<p align="center">Office Action Summary</p>	<p>Application No.</p> <p>10/025,821</p>	<p>Applicant(s)</p> <p>SHINADA ET AL.</p>	
	<p>Examiner</p> <p>Leonard S Liang</p>	<p>Art Unit</p> <p>2853</p>	<p align="center">i8</p>

DETAILED ACTION

FIG. 1

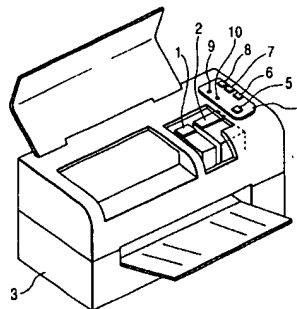
- {claim 1} An ink cartridge for an ink-jet recording apparatus (figure 1, references 1,2; figure 3B);

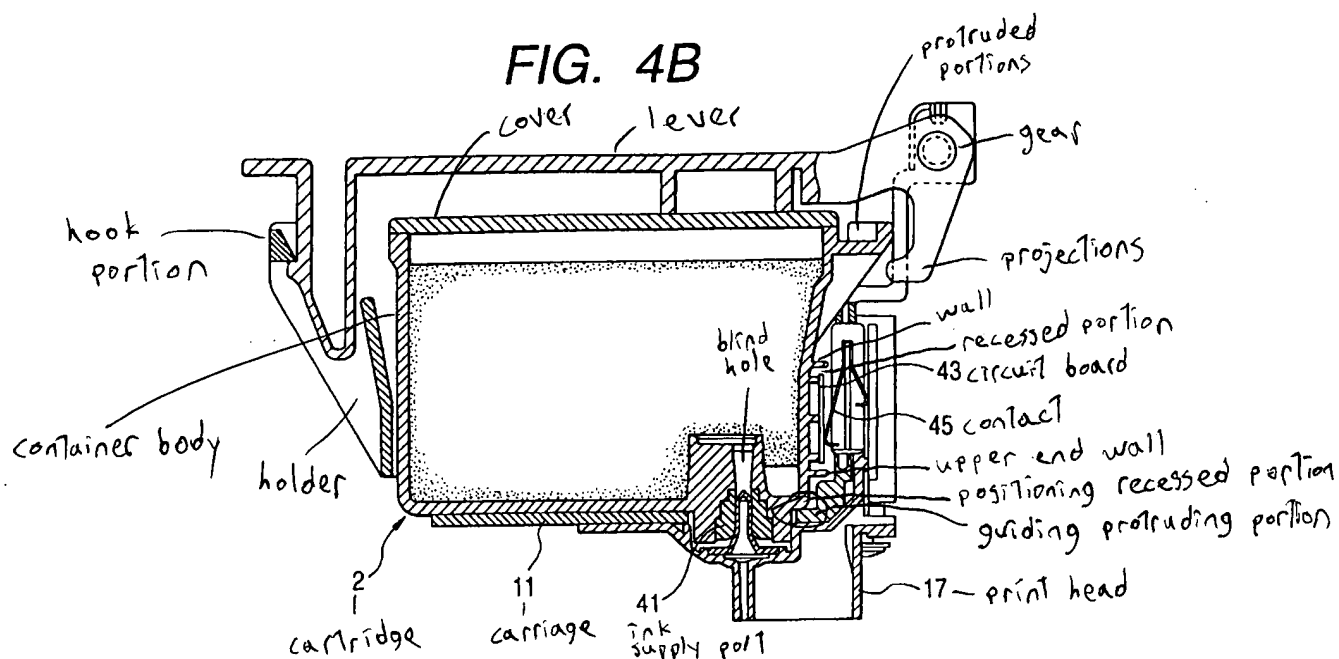
container body having an ink supply port (figure 3B, reference 41);

a storage element disposed on the container body (figure 3B, reference 42-44);

- {claim 3} at least one recess includes a pair of recesses located opposite from each other with respect to the electrodes (figure 3B; additional recess drawn in; it is seen that positioning recessed portion and additional recess are located opposite from each other with respect to the electrodes)

- {claim 5} the wall extends in parallel to a direction in which the electrodes are arranged (figure 3B; wall drawn in between contact electrodes and positioning recessed portion; it is seen that the wall extends in parallel to a direction in which the electrodes are arranged)

- {claim 6} a contact area between the wall and the positioning member is wider than a width of an area in which the electrodes are arranged (figure 3B; the width of the area between the wall and the positioning member is [W1] and the width of the area in which the electrodes are arranged [W2] are drawn in; it is seen that $W1 > W2$)

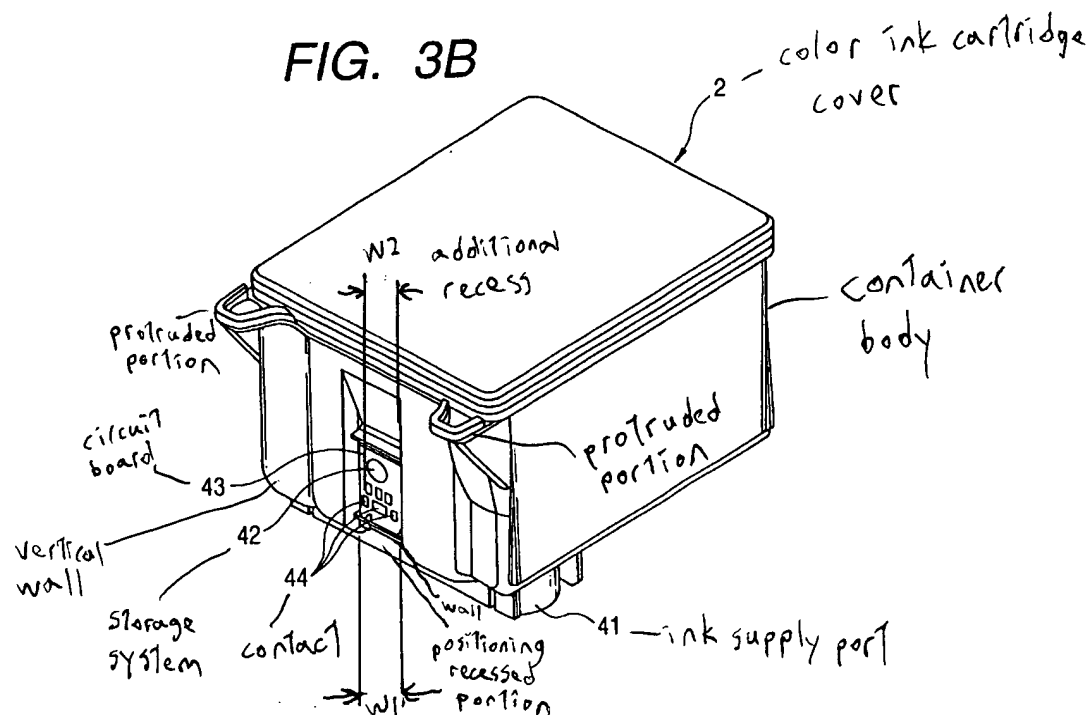
figure 4B, reference 43 and 45; contacts represent contact electrodes); a positioning system located between the ink supply port and the electrodes and is adapted to contact a positioning member of the recording apparatus to maintain the electrodes in contact with respective contacts (figure 4B, reference 43, 45; positioning recessed portion, guiding protruding portion, and ink supply needle are all drawn in and all serve as part of positioning system; contact point between positioning recessed portion and guiding protruding portion has been circled)

- {claim 2} positioning system includes at least one recess that has an opening at a leading end thereof in an ink cartridge insertion direction, and that is engageable with the positioning member formed as a protrusion (figure 4B; positioning recessed portion, guiding protruding portion drawn in; it is seen that when the lever is lifted in a counter-clockwise direction around the gear, positioning recessed portion moves away from the guiding protruding portion; thus in the alternate direction, the recess is engageable with the positioning member; thus the claim is inherent to the invention)

- {claim 4} recess has an upper end wall to be contacted with an upper end of the protrusion (figure 4B; upper end wall drawn in)

The applicant argues that Seino is silent about a positioning system and that the figures do not inherently show the claimed positioning system as alleged by the examiner. The examiner disagrees. It should be clear from figure 4B that the drawn in positioning recessed portion and guiding protruding portion form a contact which allows the circuit board 43 to remain in a contacted position with contact 45. If the two drawn in portions did not exist, references 43 and 45 would not be positioned correctly. Hence the positioning recessed portion and guiding protruding portion are integral parts of a positioning system, which allows contact between the electrodes of the print cartridge and the print head.
